Technical Memorandum for 340 West 31st Street, New York, New York
EAS and Negative Declaration
CEQR Number 10DCP033M
ULURP Number M120085AZSM
November 13, 2015

I. INTRODUCTION

A-004.00

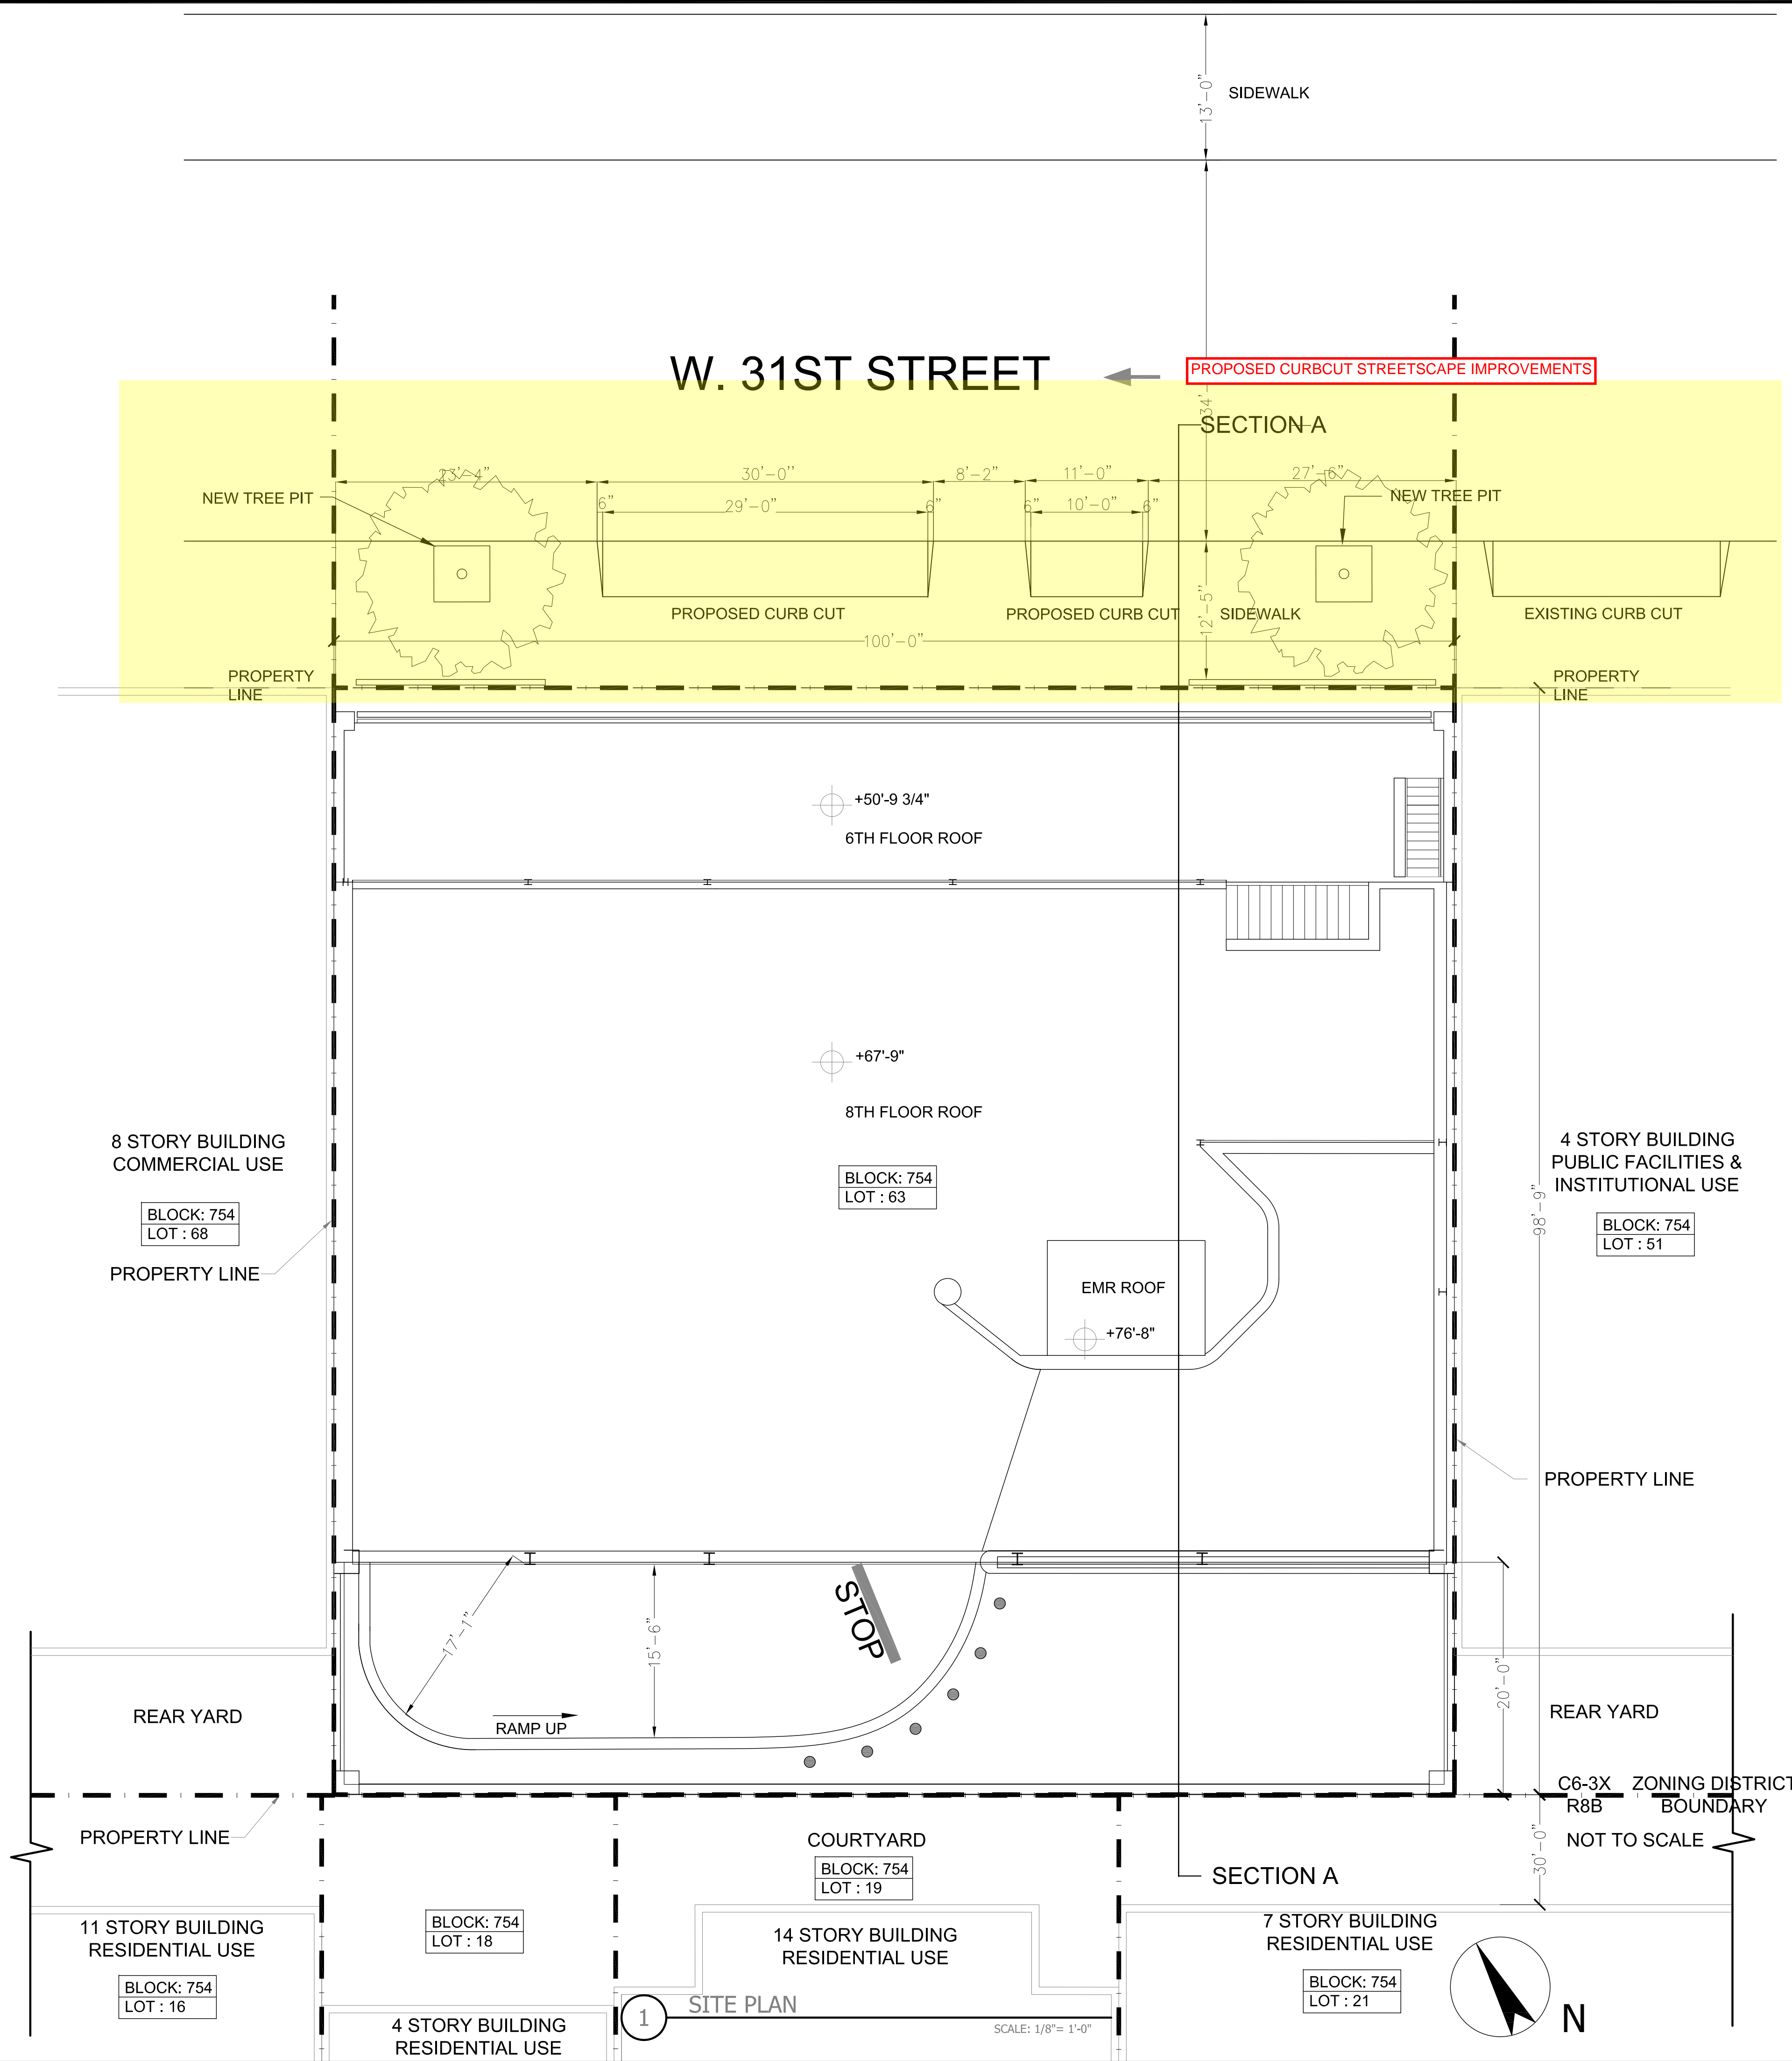
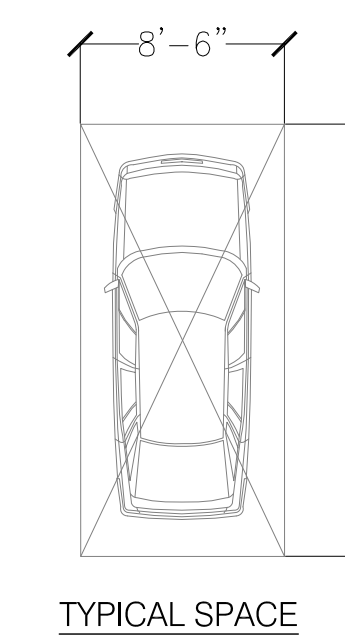
- Pedestrian walk zone
A pedestrian walk zone will be added to the ground floor between the two proposed exit ramps expanding the existing waiting area to the West 31st Street sidewalk. The existing condition of this portion of the garage is highlighted on Existing Site Plan A-003.00. The proposed pedestrian walk zone is highlighted on Proposed Modification Drawing A-004.00.

- Rear Yard Storage area
A 1,136 square foot storage area is proposed in the southeast corner of the ground floor level in an area of six existing parking spaces. The existing condition of this portion of the garage is highlighted on Existing Site Plan A-003.00. The proposed rear yard storage area is highlighted on Proposed Modification Drawing A-004.00.
